UNITED STATES PATENT AND TRADEMARK OFFICE

APPLICATION NO.	FILING DATE	FIRST NAMED INVENTOR	ATTORNEY DOCKET NO.	CONFIRMATION NO.
10/674,704	09/30/2003	Tony A. Opheim	42.P16903	4545

Office Action Summary	Application No. 10/674,704	Applicant(s) OPHEIM, TONY A.	
	Examiner Leonardo Andújar	Art Unit 2826

DETAILED ACTION

Fig. 4

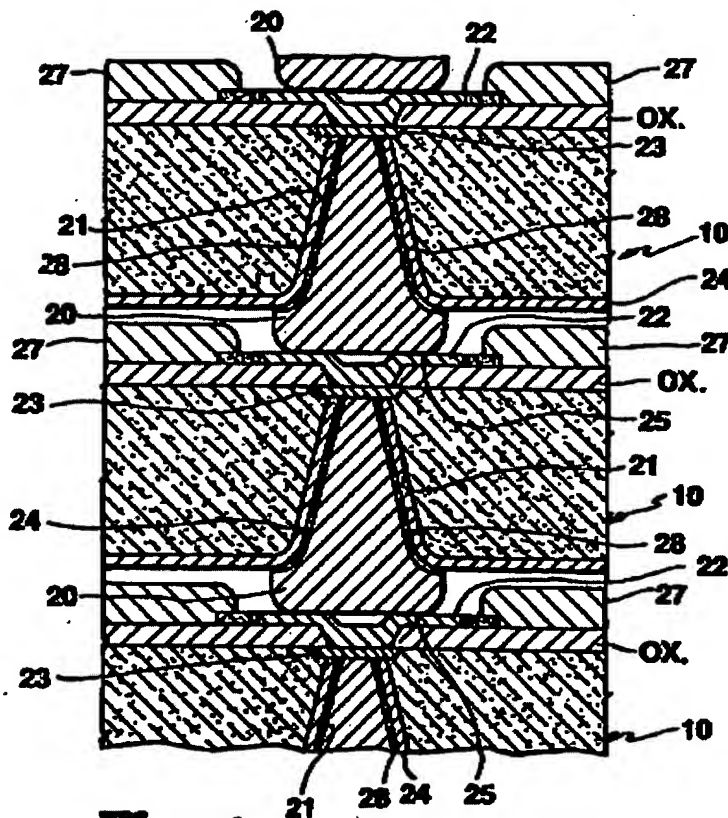
3. Claims 1, 3-7, 20, 22-24 and 27 are rejected under 35 U.S.C. 102(b) as being anticipated by Gnadinger (US 5,229,647).
4. Regarding claim 1, Gnadinger (e.g. figs. 4 and 6) shows an apparatus, comprising: a first end of a via 21 disposed in a semiconductor support layer 10, the first end (bottom end) having a first diameter; and a second end of the via having a second diameter (top end), the first diameter greater than the second diameter.

5. Regarding claim 3, Gnadinger shows that the first end forms a semi-cone in the semiconductor support layer.
6. Regarding claim 4, Gnadinger shows that a dielectric layer 24 disposed proximate to the semiconductor support layer, the via to pass through the dielectric layer (e.g. fig. 6).
7. Regarding claim 5, Gnadinger shows that a diameter of the via in the dielectric layer is similar to the first diameter.
8. Regarding claim 6, Gnadinger shows a contact 43 disposed on the dielectric layer and electrically coupled to the via.

10. Regarding claim 20, Gnadinger (e.g. figs. 4 and 6) shows a die package, comprising: a semiconductor support layer 10 including a via 21 having a first end (bottom end) and a second end (top end) in the semiconductor support layer, wherein a diameter of the first end is greater than a diameter of the second end; a dielectric layer 24 disposed proximate to the semiconductor support layer wherein the via passes through the dielectric layer; and a contact disposed 43 on the dielectric layer, the via coupled to the contact.

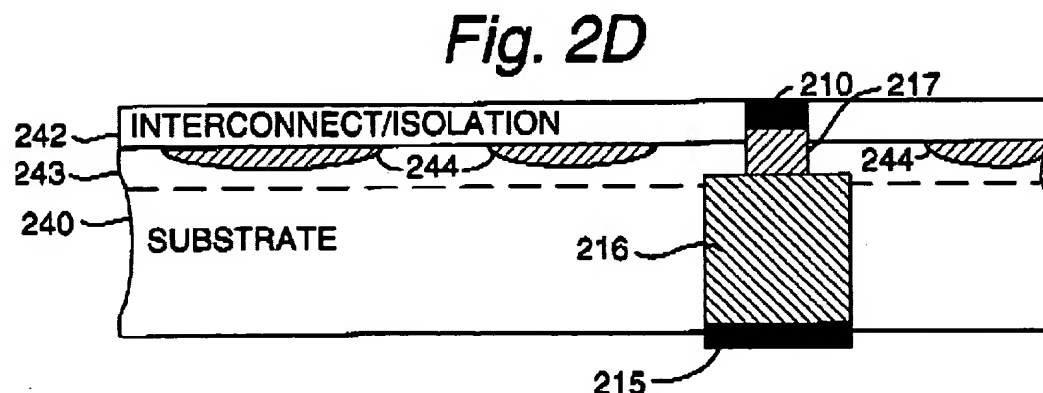
14. Regarding claim 27, Gnadinger the first diameter is approximately twice the second diameter.
